Amendments to the Drawings

Applicant respectfully requests acceptance of the following changes to the drawings shown in the attached marked up pages 1, 2 and 3. These changes are incorporated in the two (2) pages of formal drawings submitted herewith.

The present amendment is in response to the Office Action dated July 21, 2005, where the Examiner has rejected claims 1-24. By the present amendment, Independent claim 1 and dependent claims 4-7 have been amended, Independent claim 8 and dependent claims 10 and 12 have been amended, Independent claim 13 and dependent claims 17-19 have been amended, and Independent claim 20 and dependent claims 23-24 have been amended,. Reconsideration and allowance of pending claims 1-24 in view of the amendments and the following remarks are respectfully requested.

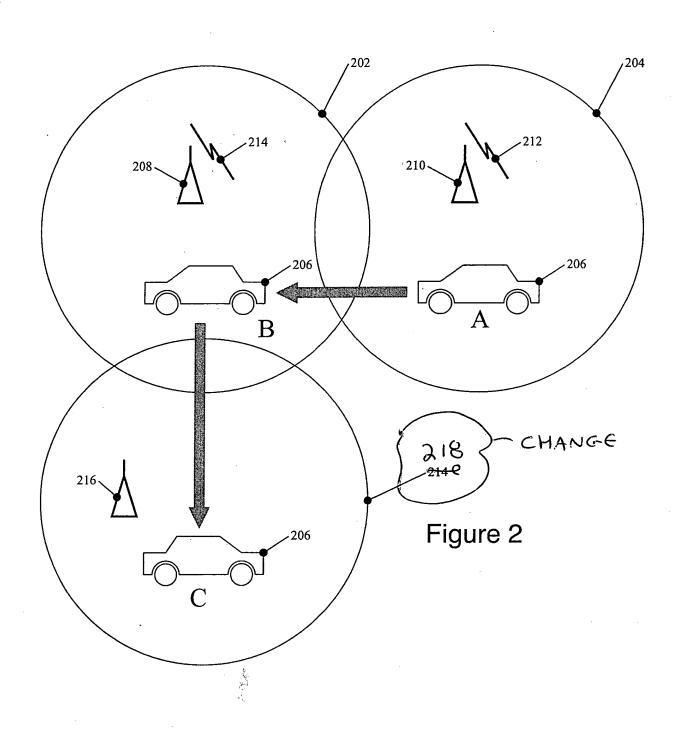
1. Amend Figure 1 block 10 as follows, this change is supported in paragraph [007] of the original specification, which states that "In step 110, the service provider then terminates the call by releasing the allocated communication channel":

Block 10 caption: End of Service Provider terminates OTA call

- 2. Amend Figure 1 by add "PRIOR ART" to the caption.
- 3. Amend Figure 2 by correcting the reference designator from "214" to --218-- as supported in paragraph [020] of the original specification.
- 4. Amend Figure 3 blocks 306 and 308 as follows, these changes are supported in paragraph [022] or the original specification, which states that "Once all OTA messages are exchanged, and the OTA session has ended, the **mobile subscriber unit** can be configured to detect the end of the OTA session in step 306. The **mobile subscriber unit** can be configured to then release the OTA call in step 308, once the end of the OTA session is detected in step 306." (emphasis added)

Figure 3

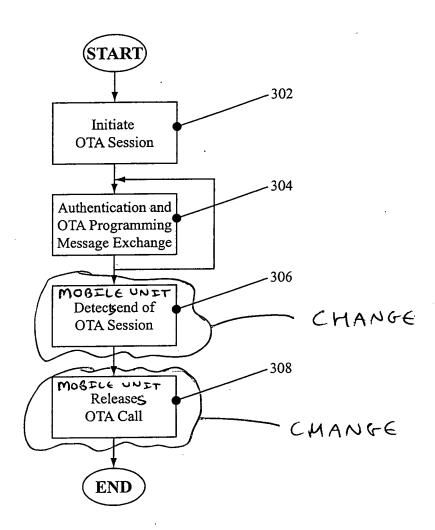
Block 306 caption: Detect Mobile Unit detects end of OTA Session

Block 308 caption: Release Mobile Unit releases OTA Call
